Our Ref: N-15042

**RE: S75W MODIFICATION APPLICATION - THE DAN LAND - MP 06_0031 (MOD 4) -
RESPONSE TO SUBMISSIONS**

Left: Proposed Lot 114 boundary as originally proposed within this modification application. **Right:** Proposed Lot 114 boundary as amended in response to the requirement for a perimeter access road.

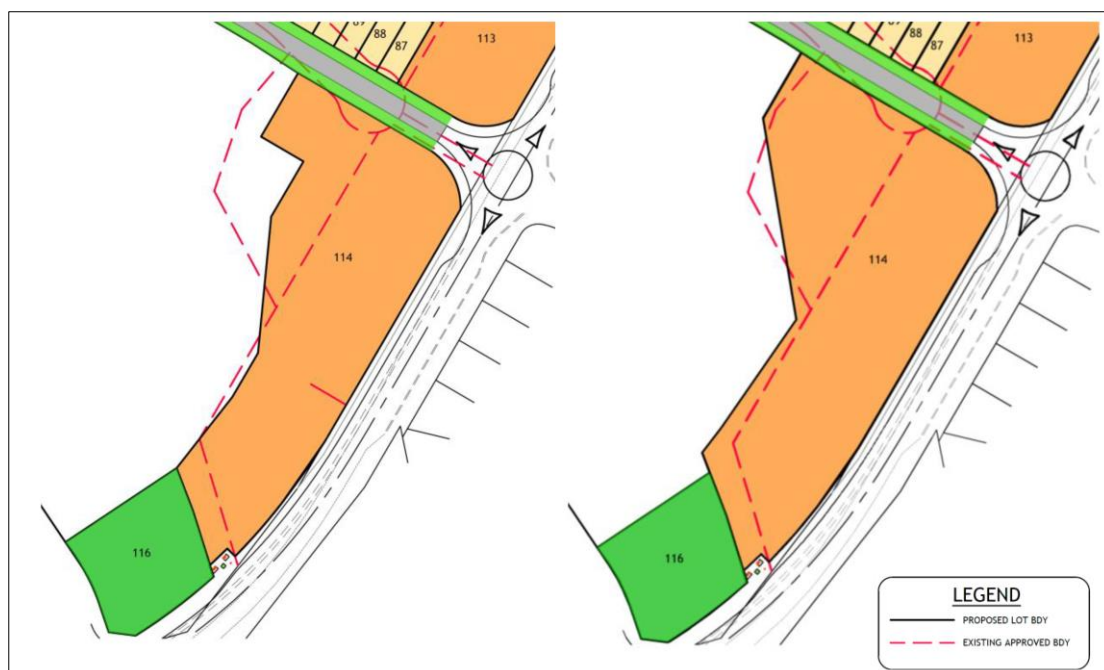
In response to the submission from the Rural Fire Service, a bushfire assessment specifically for Stage 10 was undertaken by Australian Bushfire Protection Planners (see **Attachment 2** to this letter). As a result of this assessment, it was determined that a perimeter access road will be required along the northern boundary of proposed Lot 114, one of the two super lots intended for future medium-density housing development. Further, an additional Asset Protection Zone will be required along the northern boundary of this site.

Accordingly, it is proposed to relocate the boundary of proposed Lot 114 slightly further to the north to allow for the required fire-fighting access whilst maintaining the flexibility to achieve an efficient medium-density housing layout.

The proposed amended position of the super lot boundary is shown in the Figure below, in comparison to the position originally proposed as part of this modification application. A full plan showing the amended boundary in the context of Stage 10 is provided at **Attachment 3**. A plan showing the position of the proposed amended boundary in relation to the approved boundary is provided at **Attachment 4**.

- Whilst the modified boundary would extend slightly beyond what was originally approved in this location, the overall area of development throughout Stage 10 is still less than what was originally approved by approximately 7,000m² (as a result of topographical constraints).
- The amended boundary would still be contained within the appropriate R2 Low Density Residential zone, as indicated in **Attachment 5**.
